Subject: AP1000 Responses to Requests for Additional Information (TR-85)

Westinghouse is submitting responses to the NRC request for additional information (RAI) on AP1000 Standard Combined License Technical Report 85, APP-GW-GLR-044, "Nuclear Island Basemat and Foundation." These RAI responses are submitted in support of the AP1000 Design Certification Amendment Application (Docket No. 52-006). The information included in the responses is generic and is expected to apply to all COL applications referencing the AP1000 Design Certification and the AP1000 Design Certification Amendment Application.

Responses to Requests for Additional Information on Technical Report No. 85

# AP1000 TECHNICAL REPORT REVIEW

**Figure RAI-TR85-SEB1-04-1 – ANSYS NI20 Model**

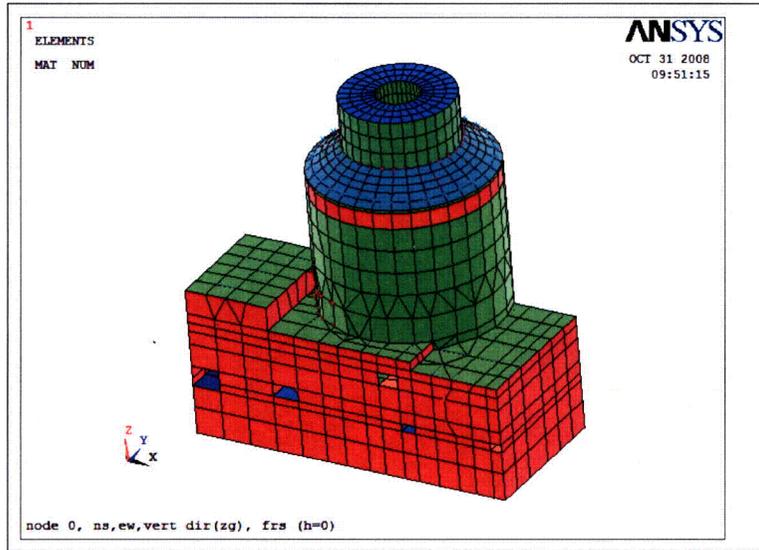
a. The 3D finite element analysis model [NI20], listed on page 1 of 7 of the RAI response, indicates that it was used in a response spectrum analysis with seismic input enveloping all soil cases for overturning and stability evaluation. Explain an apparent inconsistency with the analyses in the proposed revision to DCD Table 3G.1-1 in the RAI response.

(2) The stability evaluations (for sliding and overturning) are based on a 3D NI20 model time history analysis (linear no lift-off), and not a response spectrum modal analysis. This is consistent with Table 3G1-1 given in DCD Appendix 3G, Revision 17 (see also response to RAI-TR85-SEB1-34). The model used is shown in Figure RAI-TR85-SEB1-04-1. As noted in Section 2.4.2 to Technical Report 85, "Comparison of floor response spectra and the maximum member forces and moments for these two cases show that the liftoff has insignificant effect on the SSE response." Therefore, it has been concluded that liftoff will have insignificant effect on the forces and moments that are being used for seismic stability evaluation.

- a. As noted in item (2) above, time history analyses are used and not seismic response spectrum analyses for the overturning and stability evaluation. This is consistent with Table 3G1-1 given in DCD Appendix 3G, Revision 17.
- b. In Table 3G.1-2, DCD Revision 17, the NI05 model is identified in the third and fourth rows. The basemat is modeled in the NI05 model. In Table 3G.1-1, DCD Revision 17, NI05 is identified on sheet 1, 5<sup>th</sup> row, and on sheet 3 the 7<sup>th</sup> row.

Figure 2.4-1: SASSI Basement Model (YZ Plane)

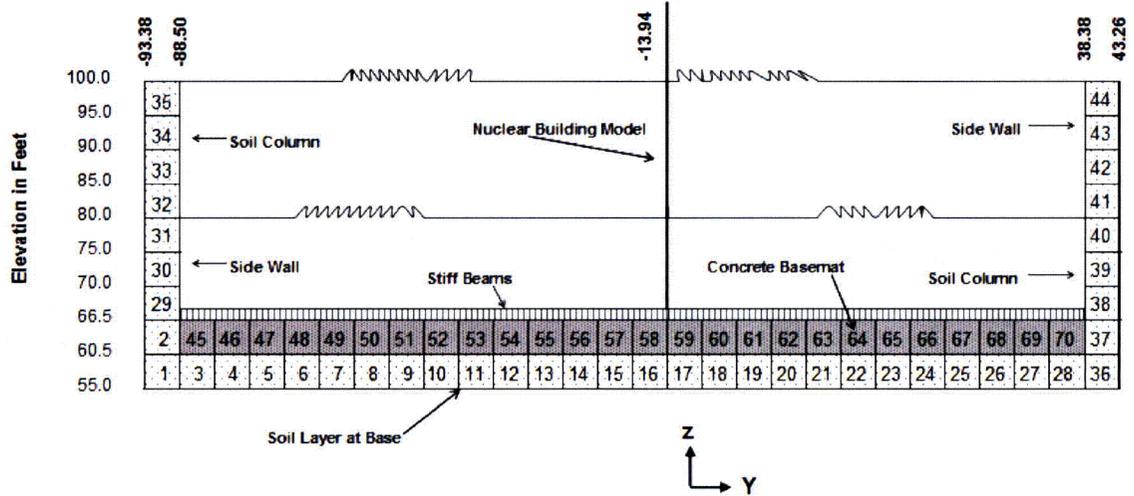
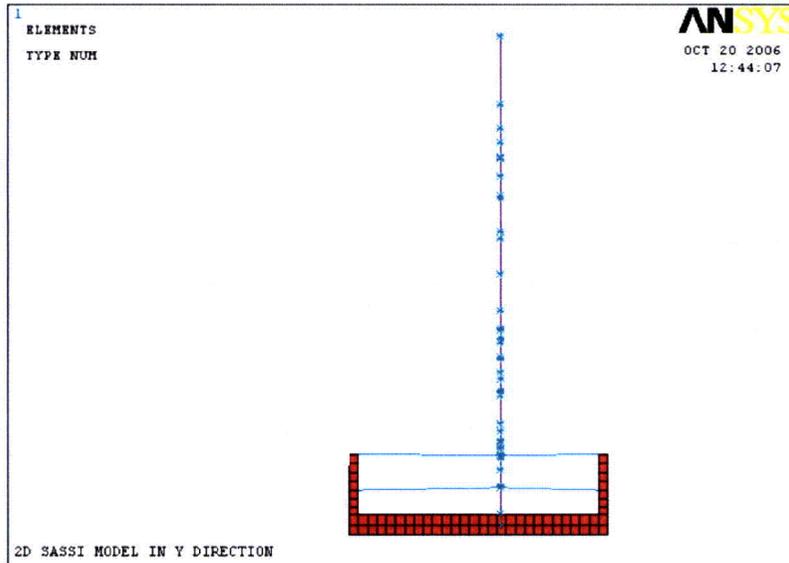
1. Provide a detailed figure of the 2D SASSI model and a description of the analysis approach. The figure should include all of the information referred to in the RAI response.
2. The RAI response did not address the request made in the RAI. Westinghouse is requested to show whether the 2D SASSI results bound the 2D ANSYS results. TR85, Rev. 0, stated that the 2D SASSI results were used for evaluation of the nuclear island stability calculations. This could be done for the governing stability cases for overturning and sliding. When this comparison is made, it should be done for the same soil profile(s) in both analyses in order to have a consistent comparison.

Parametric 2D SASSI linear elastic analyses were performed for a variety of soil conditions as described in Section 4.4.1.2 of Reference 3. The SASSI model in the east west direction is shown in Figures 2.4-1 and 2.4-2. These analyses used AP1000 building models comprising 3 sticks (ASB, CIS and SCV). Six soil cases with shear wave velocity profiles shown in Figure 2.4-3 were analyzed in each direction. Bedrock with shear wave velocity of 8000 fps was assumed at a depth of 120' below grade. Thus the depth of soil below the foundation mat is 80.5'. The building models used in the parametric analyses were updated to include changes to the nuclear island such as the change to the enhanced shield building. The properties of the ASB and CIS in the NI combined stick model are developed to match the properties of the nuclear island shell models.

1. A detailed figure of the 2D SASSI model and a description of the analysis approach is included in the proposed revision to TR85 provided in the Revision 1 response to RAI-TR85-SEB1-05.

Figure 2.4-3 Generic Soil Profiles

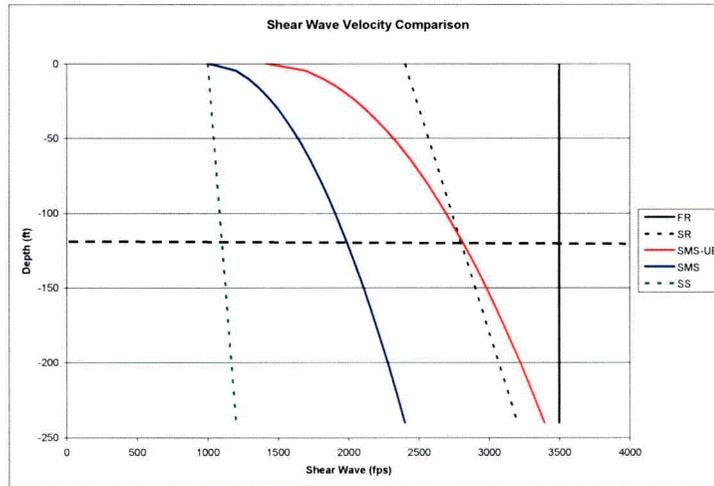
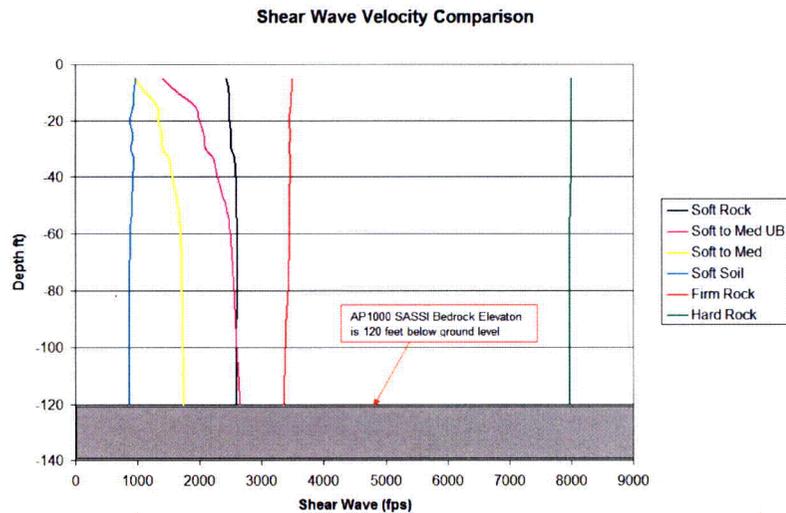
- b) Section 2.4.1 indicates that six soil cases with shear wave velocity profiles shown in Figure 2.4-1 were analyzed. However, Figure 2.4-1 only shows five soil cases. Furthermore, Section 4.4.1.2 of TR-03, Revision 0, indicates that four design soil profiles were used, while Table 4.4.1-1B of that report shows six soil cases. Explain all of these differences.

- b) As described in Section 2.4.1, six soil cases with shear wave velocity profiles shown in Figure 2.4-34 were analyzed in 2D SASSI. Figure 2.4-34 shows the five soil cases with shear wave velocity up to 3500 fps. The hard rock is shown in the footnote with shear wave velocity of 8000 fps. This was done to show the differences in the lower shear wave velocity cases more clearly.

Figure 2.4-6 – 2D ANSYS Time History of Basemat Edges

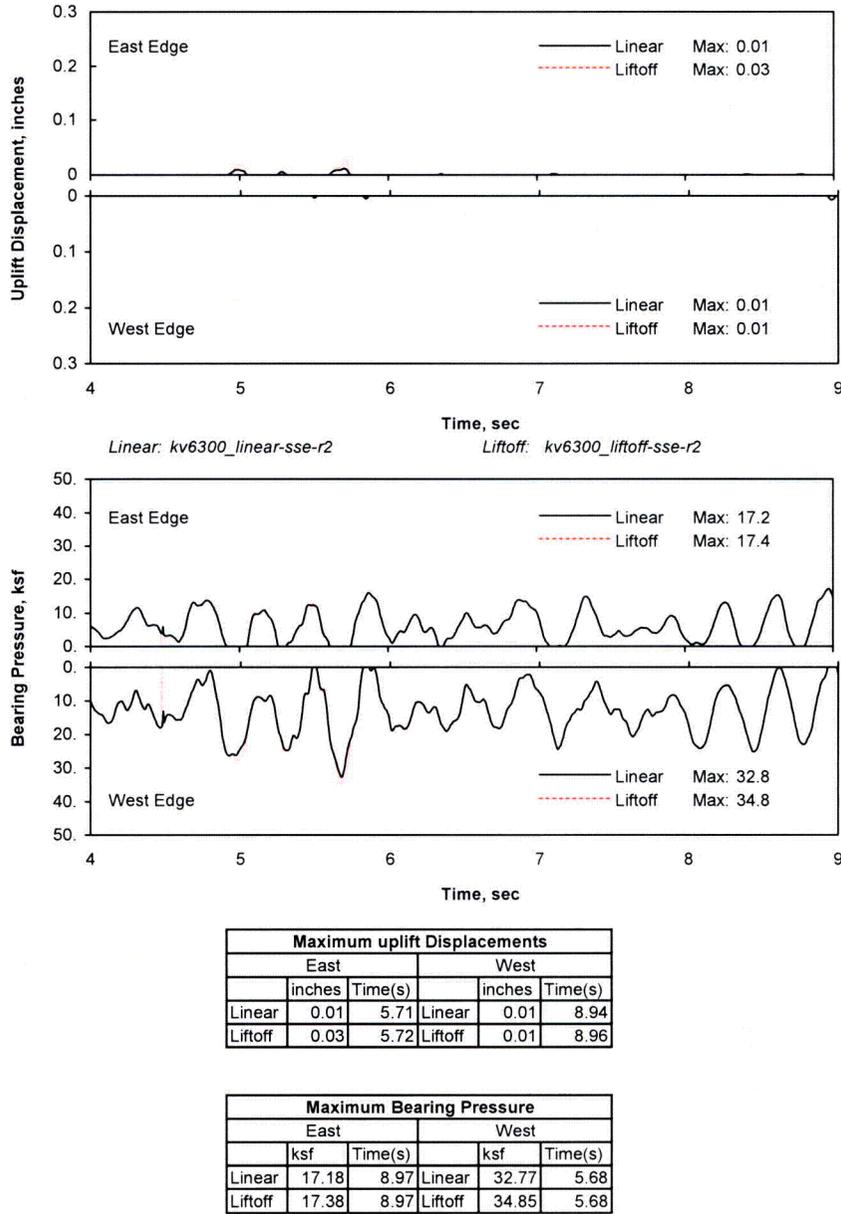
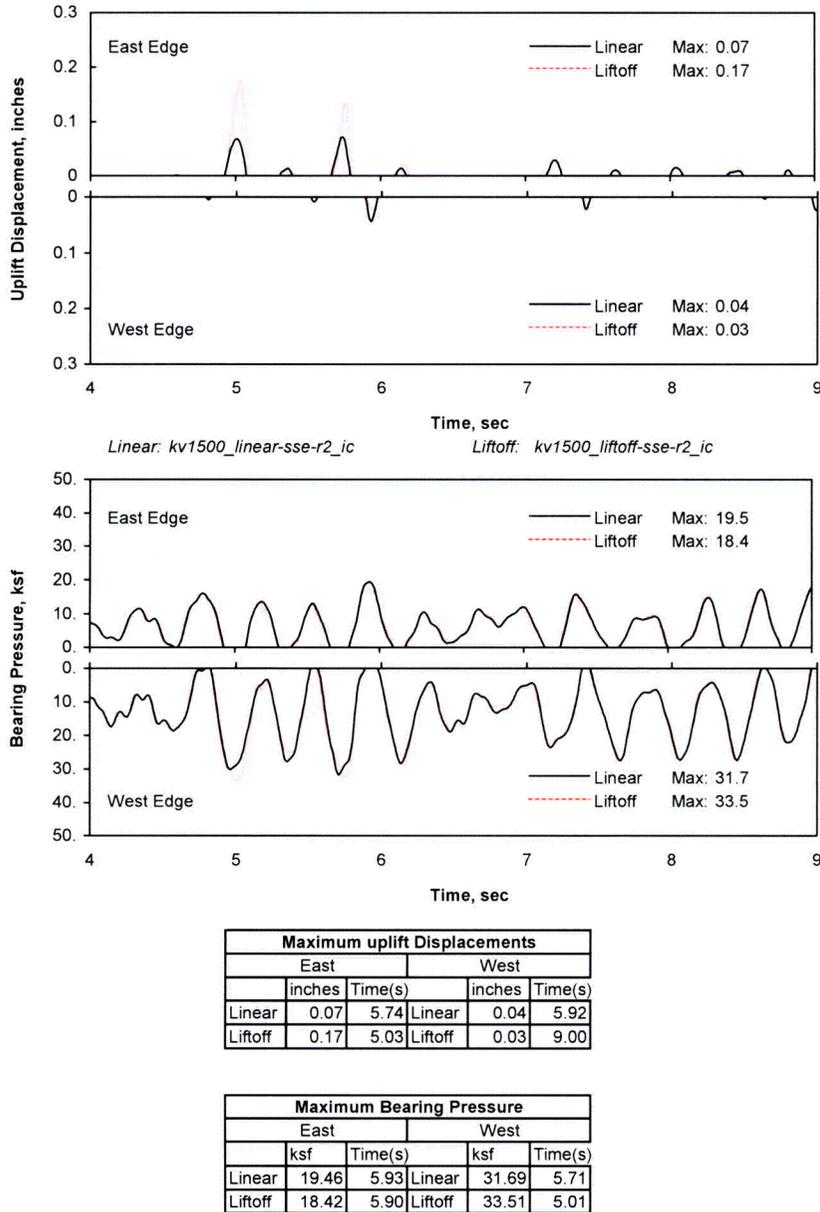
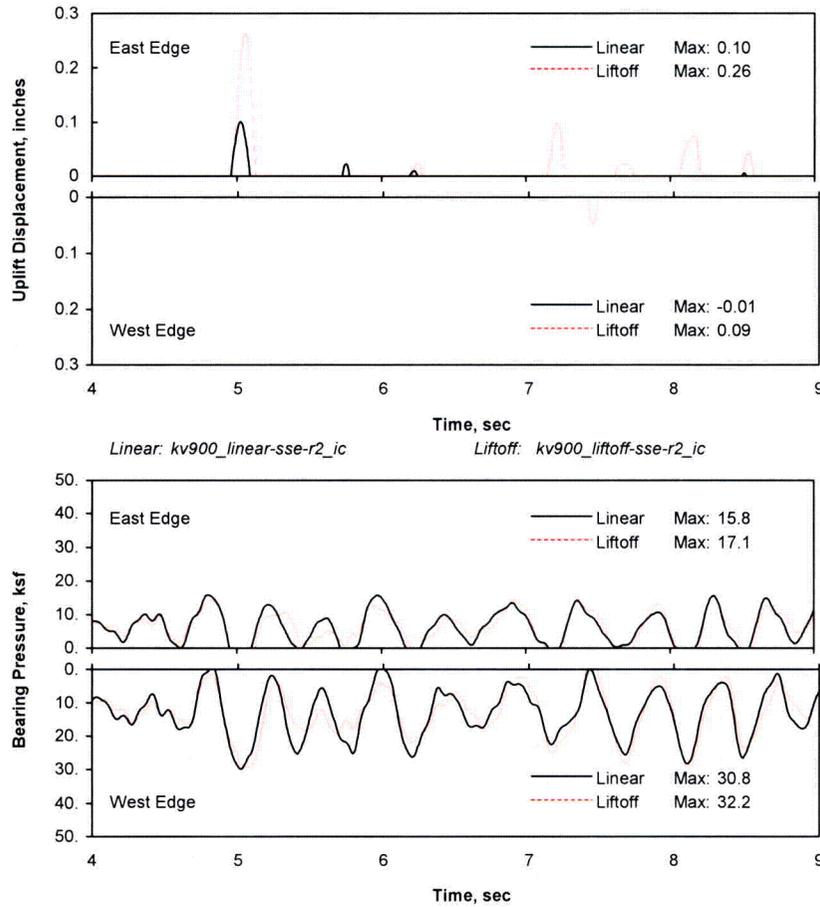
The staff reviewed the RAI response provided in Westinghouse letter dated 9/18/07. The response does not adequately demonstrate why the current seismic analysis, using the 2D ANSYS non-linear dynamic analysis, results in such a large reduction of the bearing capacity from 120,000 psf to 35,000 psf, which is a factor of 3.4 times smaller. Westinghouse is requested to

Figure 2.4-6 shows the time history of the deflection and pressure at the west and east edge around the time that the peak pressure occurs at the west edge. The three sheets show results for hard rock (HR), upper bound soft to medium (UBSM) and soft to medium (SM). The linear results show maximum bearing pressures on the west side of 31 to 33 ksf. Lift off increases the subgrade pressure close to the west edge by 4 to 6% with insignificant effect beneath most of the basemat. The effect on the pressure at the west edge is significantly less than that calculated in the non-linear basemat analyses using equivalent static accelerations.
